## Downtown Parking Lot (#202)

**ADDENDUM DATE: NOVEMBER 28, 2017**

**ADDENDUM NO. 1**

### Addition/Change to the Contract Documents

STANDARD DRAWING TITLE		DRAWING NUMBER	
	SINGLE WATER SERVICE - CURB TIGHT		W-7C	
	Any alteration of this drawing may not be associated in any way with the City of Sherwood Standard Drawings.	SCALE		DATE
		N.T.S.		MAR '16

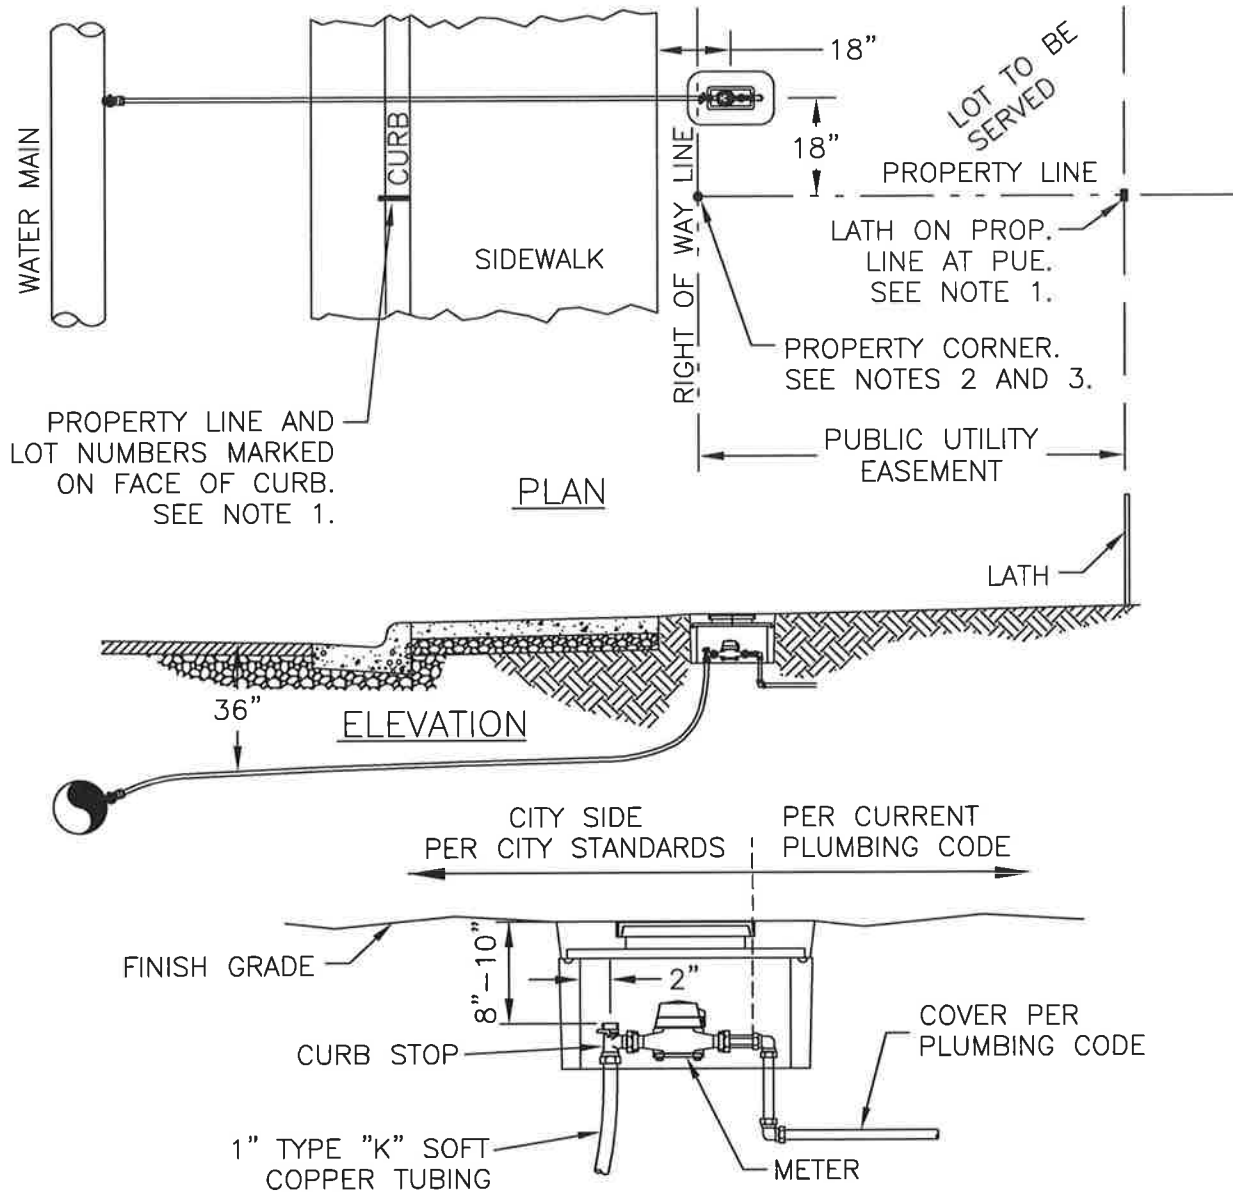
5. Can you provide some City standard details for the 1" water service for the irrigation system? Who will pay for the permit for this work and any associated fees (SDC's)? Does the City provide the meter?

*Response: The details for the irrigation water system connection and meter setup follow the City's details for domestic water service. City standard detail W-7C will be followed for providing the irrigation water system connection and meter setup. The City standard detail W-7C is made a part of this addendum. The URA will pay for any permit fees. The City Public Works Department provides the meter, and will either dig-in or drop-in the meter assembly. Contact the City Public Works Department to arrange for the meter installation.*
